May 9, 2013
E-35275

Subject: Revision 7 to Transnuclear, Inc. (TN) Application for Amendment 3 to Standardized Advanced NUHOMS® Certificate of Compliance No. 1029, Response to Request for Additional Information (Docket No. 72-1029; TAC No. L24607)

CHAPTER 4 – THERMAL EVALUATION

Figure B.4.5-14
Maximum Fuel Cladding Temperature versus Number of Elements

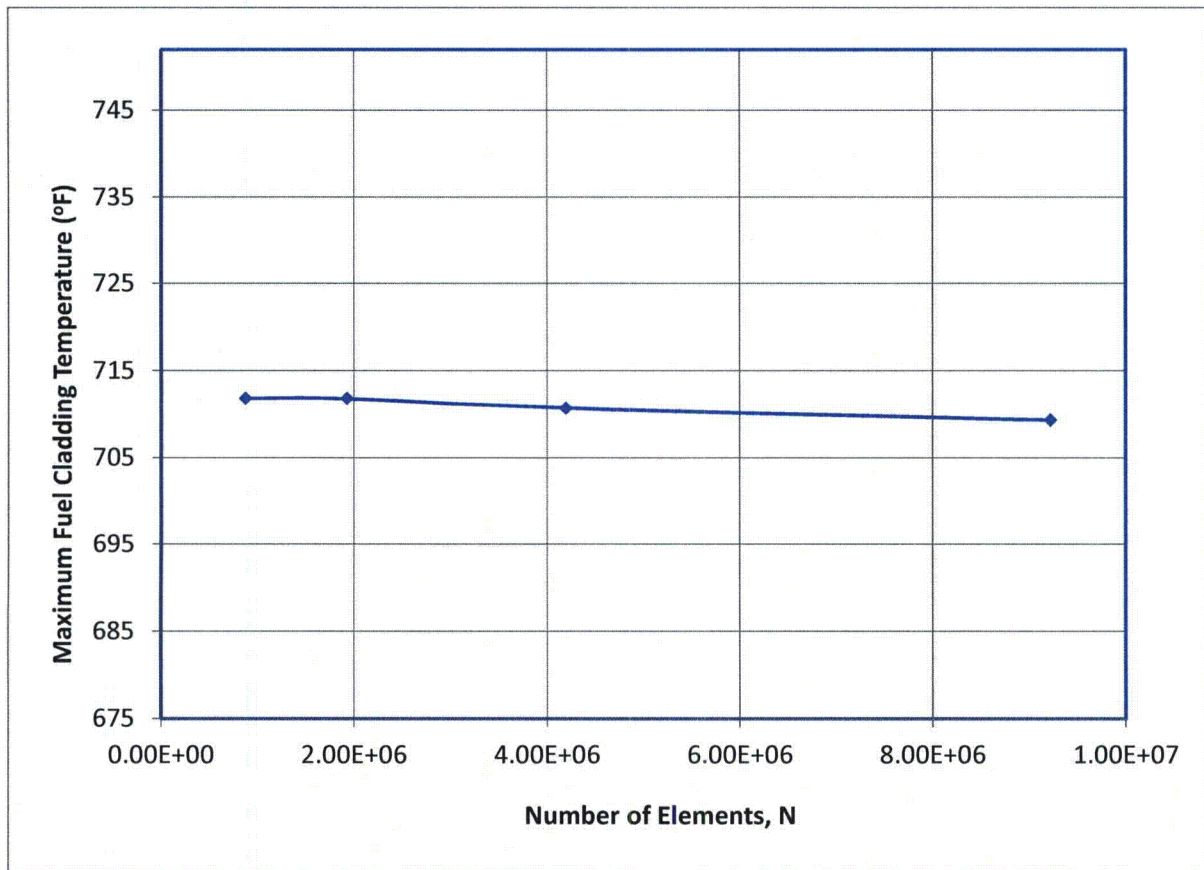
- 4-2 Demonstrate that the results from the grids used in the grid convergence studies can be represented as a normal distribution in order to obtain the discretization error. Otherwise, use the GCI to obtain the discretization error.

Table B.4.6-22 of FSAR Revision 3 provides the calculated discretization error. However, the error is calculated assuming the results from the grid study follow a Gaussian (normal) distribution. For additional information, see page 14 of ASME V&V 20-2009.

The results of the grid convergence studies presented in UFSAR Section B.4.6 are revised to use the GCI in determining the discretization error, as suggested.

Figure B.4.5-15
Model Grid Density Used for Grid Convergence Study

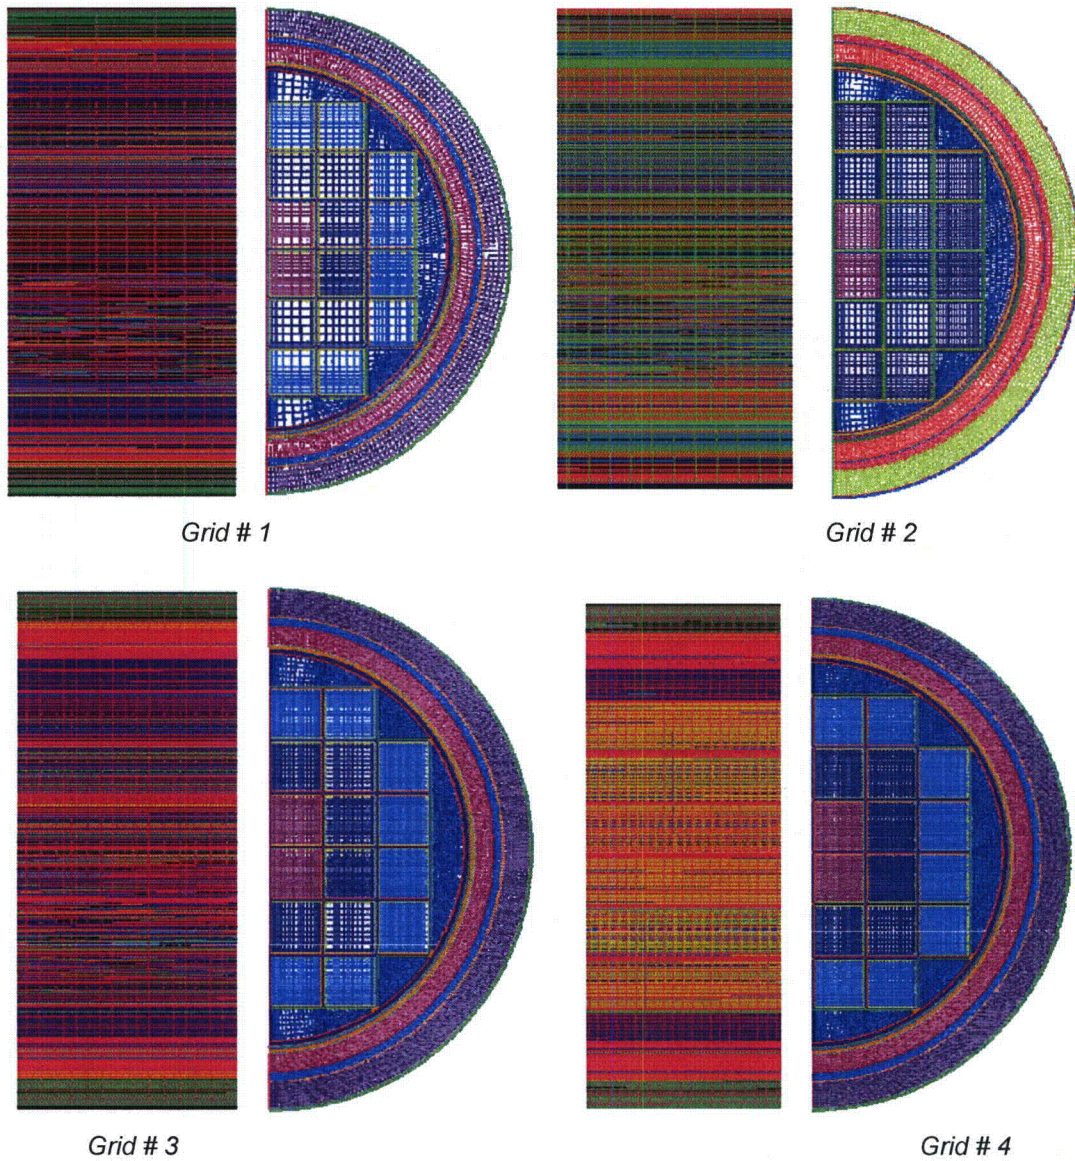
- 4-4 Obtain the analysis discretization error for the CFD analysis described in response to RAI 4-7 using the entire modeled geometry and not just a slice of the model by calculating the GCI following the procedure described in American Society of Mechanical Engineers Verification and Validation 20-2009 (ASME V&V 20-2009), "Standard for Verification and Validation in Computational Fluid Dynamics and Heat Transfer".

The CFD model used to obtain the GCI appears to represent only a slice of the model and not the entire geometry. As such, this model does not appear to capture the heat transfer and fluid flow characteristics of the intended geometry which includes specified mass flow rate at the inlet and a pressure boundary at the outlet (see response to RAI 4-14).

The CFD model used to obtain the GCI uses the entire modeled geometry. Only slices of the entire CFD model were selected to visualize the mesh density in the depictions shown in Figure A-2 of Calculation 13206-0416, Rev. 0 (provided as Enclosure 3 to TN-E-34062 on December 11, 2012). Since the mesh density of some of the models used for the GCI studies is too dense, showing the entire model in those depictions would have resulted in illegible pictures. The computation files submitted in Enclosure 5 to TN E-34062 in response to RAI 4-7 provide the evidence that the entire geometry was used for the GCI study of the CFD model. Clarifications are added in the description of the GCI study for the CFD model in UFSAR Section B.4.5.4.3.1 to avoid the appearance of using a slice model from the GCI study.
